# RENESAS TECHNICAL UPDATE

Product Category	MPU&MCU		Document No.	TN-H8*-A405A/E	Rev.	1.00
Title	Correction of errors in the H8SX/1653 Group Hardware Manual		Information Category	Technical Notification		
Applicable Product	H8SX/1653 Group	Lot No.	Reference Document	H8SX/1653 Group Hardware Manual (REJ09B0219-0100)		
		All lots

(1) Page 308, DTCER description in figure 8.1, Block Diagram of DTC

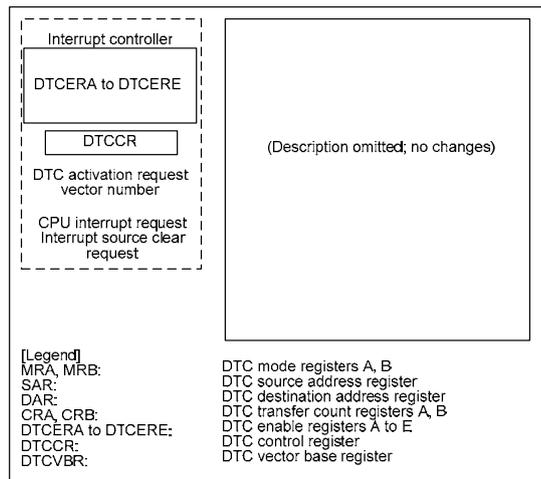
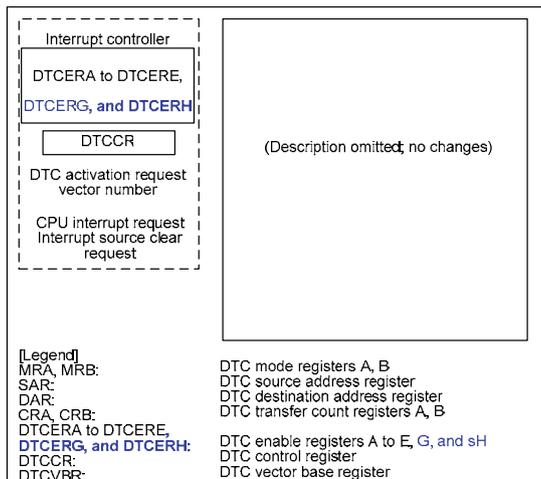
Deletion of DTCERG, and DTCERH in DTCER

[Before Change]

[After Change]
